**STATE SIGNIFICANT DEVELOPMENT:
Section 96(1A) Modification Application**

**SICEEP, DARLING SQUARE, SOUTH WEST PLOT,
SYDNEY**

SSD 6011 MOD 2

Environmental Assessment Report
Section 96(1A) of the *Environmental Planning
and Assessment Act 1979*

Figure 3: Ground floor plan modifications.

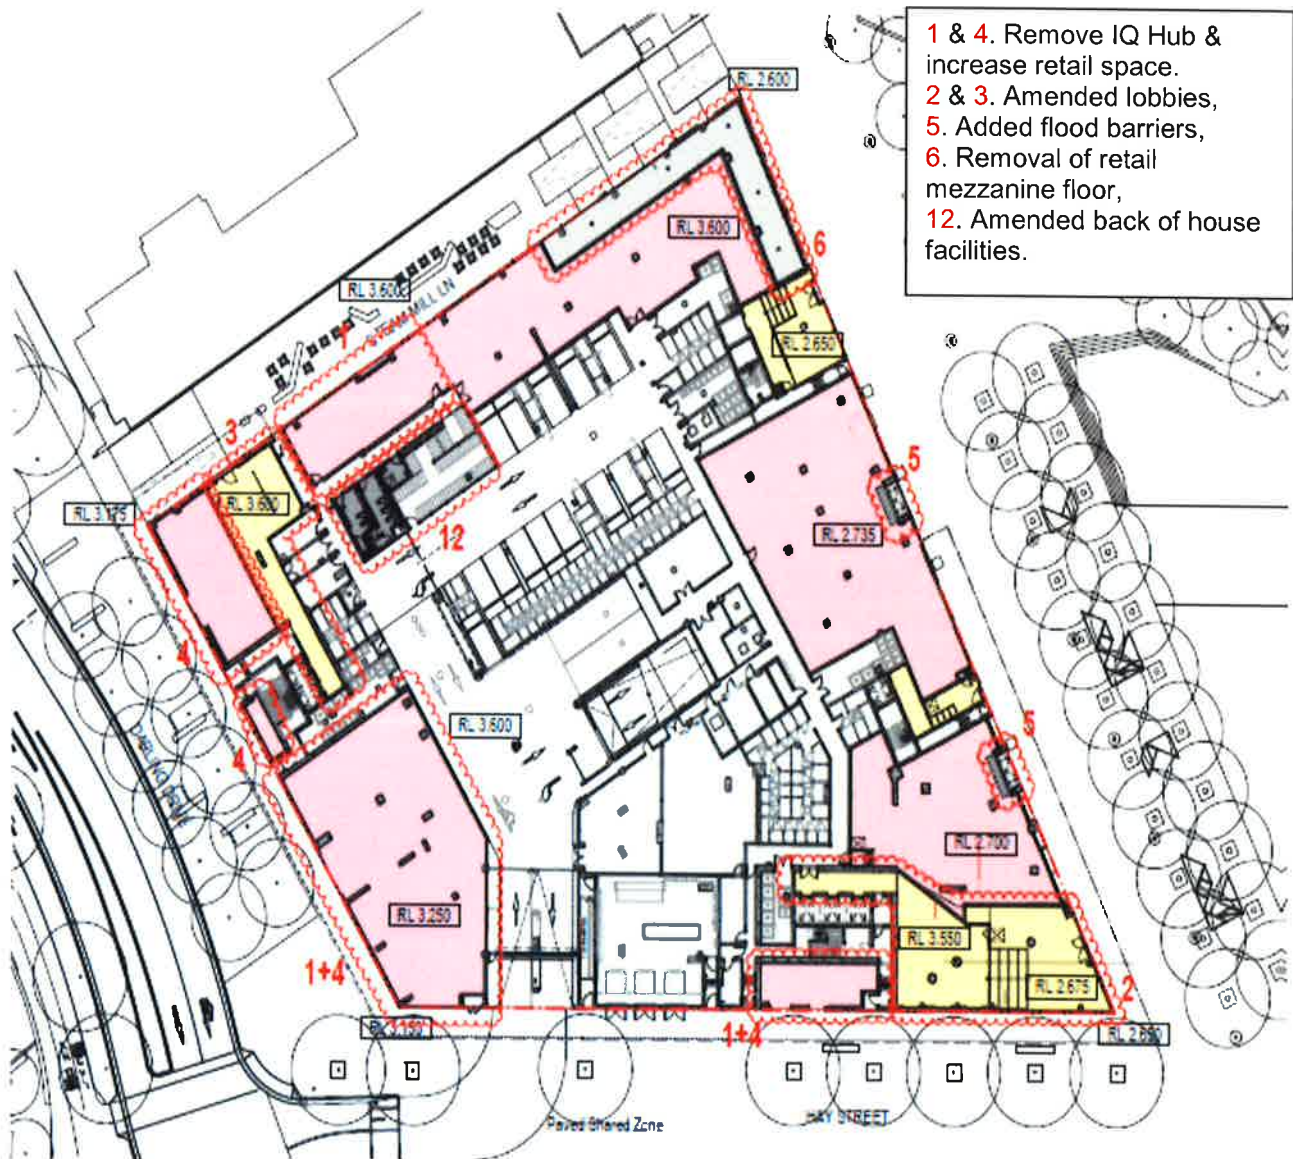
The modification proposes a number of changes to the ground floor including:

- reduction in size (by 112m²) of the lobby for building SW1 and the entrance from Darling Drive deleted. The entrance from Steam Mill Lane will remain;
- consolidation of the mail room with the lobby for building SW3 and creation of a new retail tenancy along the Hay Street frontage. Changes to the proportion of glazed and solid wall are also proposed in this location;
- deletion of the mezzanine floor within the retail space in building SW2, at the corner of Steam Mill Lane and The Boulevarde. An outdoor terrace adjacent to this retail space is also proposed; and
- the space previously to be used for the IQ Hub (as discussed in **Section 5.3**) will become available for retail tenancies.

The Department is satisfied that the proposed ground floor amendments will not result in any detrimental impacts to the surrounding area, the development and for residents or visitors to the site. The provision of additional retail tenancies will provide greater activation along Darling Drive, Hay Street and Steam Mill Lane frontages and provide a greater range of services or shopping in the expanded retail floor space. The Department therefore supports these modifications.

Figure 4: Proposed modifications, east elevation.

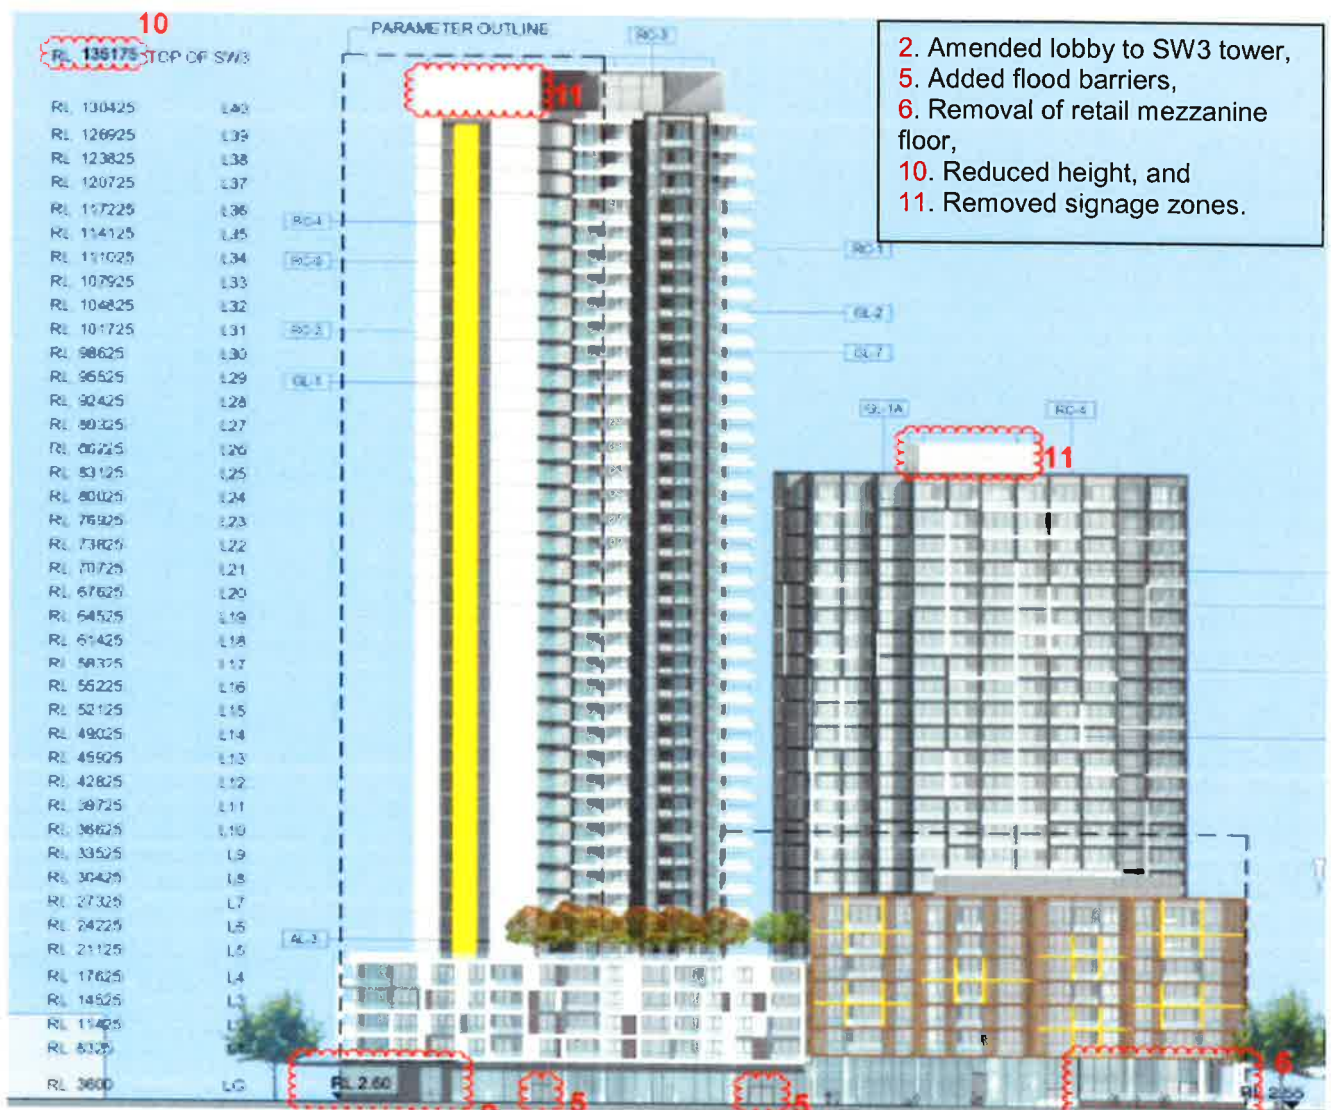
On 6 December 2016, the Applicant lodged an application (SSD 6011 MOD 2) seeking approval to amend the approved development as a result of further design development. The proposed modifications are outlined in below and key changes are shown in **Figures 3 and 4**:

- revised lobbies and facades at the podium level to buildings SW1 and SW3;
- replacement of the ground floor space previously reserved for the IQ Hub with retail space;
- fixed canopies replaced with umbrellas and retractable canopies along Steam Mill Lane;
- removal of the mezzanine level from within the retail space in the north-east corner, and adding an outdoor terrace;
- amending windows and glazing type to apartments in buildings SW1 and SW3;
- reduce the height of building SW3;
- reduce total GFA;
